Office Action Summary	Application No.	Applicant(s)	
	10/776,870	KRIEGER ET AL.	
	Examiner	Art Unit	
	TRONG PHAN	2827

DETAILED ACTION

Fig. 8

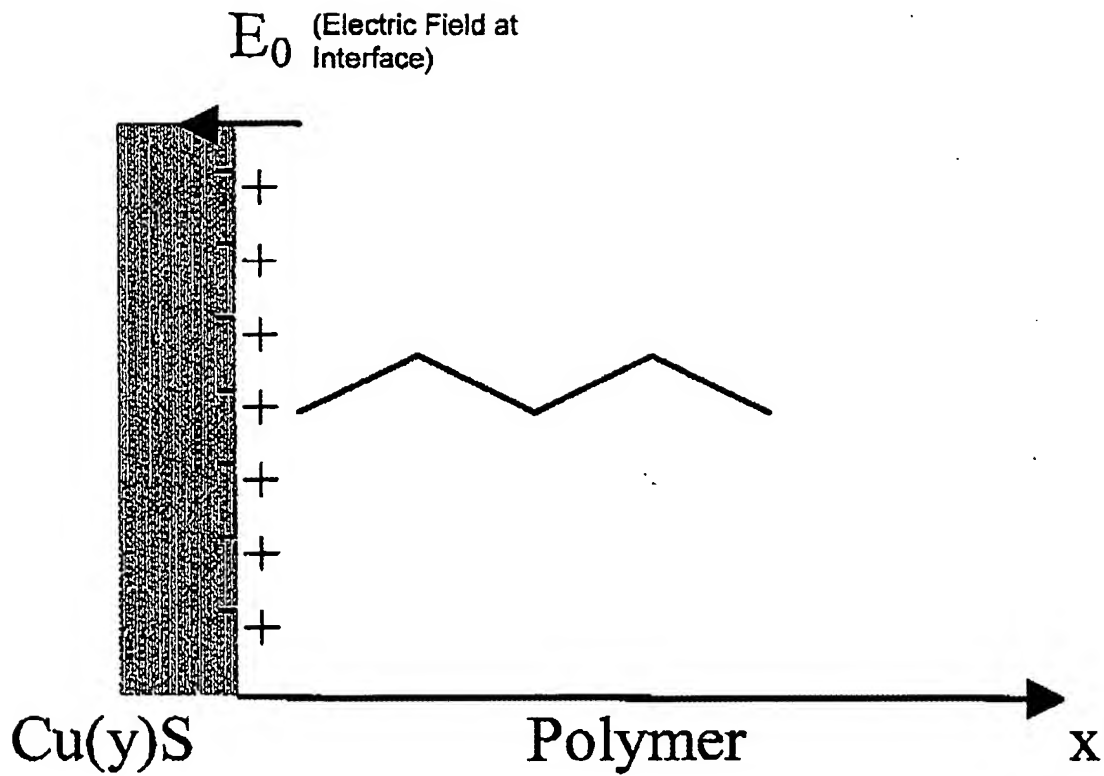
1. The drawings are objected to as failing to comply with 37 CFR 1.84(p)(5) because they do not include the following reference sign(s) mentioned in the description: the write and read circuits (lines 27-28, page 13). Corrected drawing sheets in compliance with 37 CFR 1.121(d) are required in reply to the Office action to avoid abandonment of the application. Any amended replacement drawing sheet should include all of the figures appearing on the immediate prior version of the sheet, even if only one figure is being amended. Each drawing sheet submitted after the filing date of an application must be labeled in the top margin as either "Replacement Sheet" or "New Sheet" pursuant to 37 CFR 1.121(d). If the changes are not accepted by the examiner, the applicant will be notified and informed of any required corrective action in the next Office action. The objection to the drawings will not be held in abeyance.

2. The drawings are objected to under 37 CFR 1.83(a). The drawings must show every feature of the invention specified in the claims. Therefore, the write and read circuits that program the memory cell as recited in claim 8 must be shown or the feature(s) canceled from the claim(s). No new matter should be entered.
